SECTION 009117
ADDENDUM NUMBER 7

- 1.1 DATE: January 21, 2022
- 1.2 PROJECT: Orangetown Town Hall Addition and Alterations
- 1.3 Owner: Town of Orangetown
- 1.4 Architect: Lothrop Associates LLP Architects

E-202

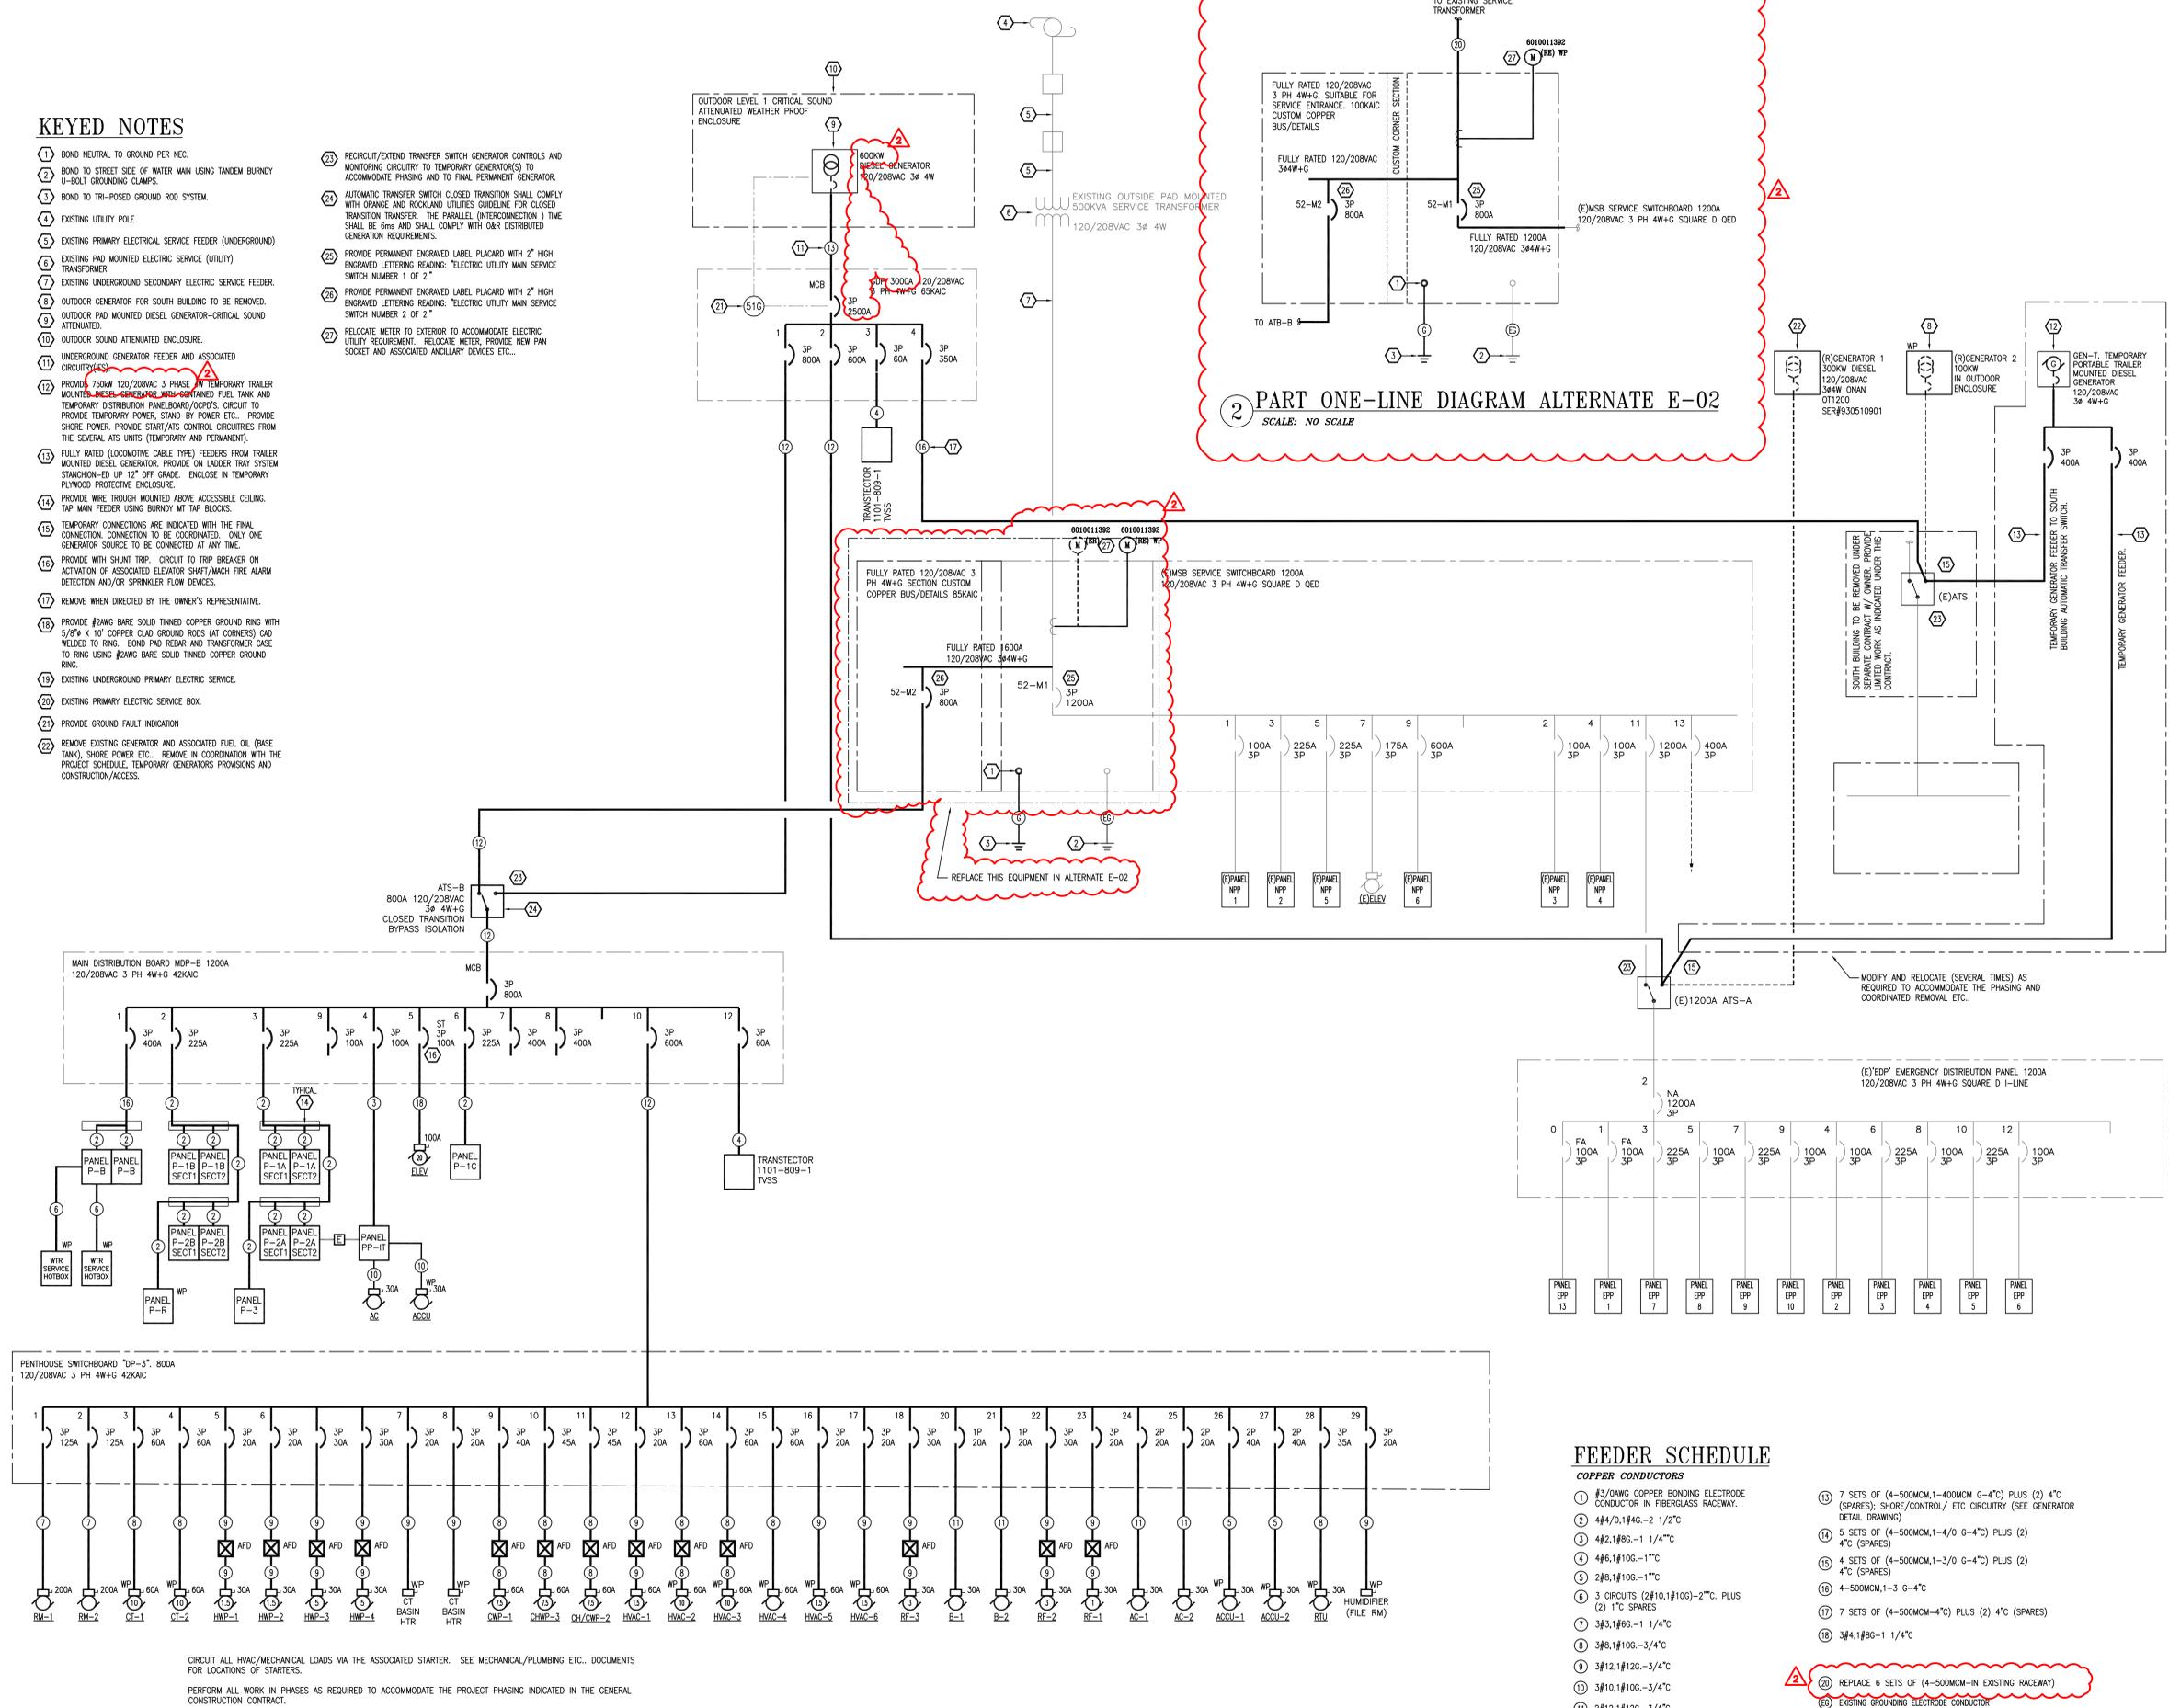
- 5.3 DRAWING E-202 - ELECTRICAL BASEMENT LEVEL FLOOR PLAN (POWER)
 - A. **Remove and replace Drawing E-202, Issue 1 with new Drawing E-202, Revision 1 Addendum No. 7, attached to this Addendum.**
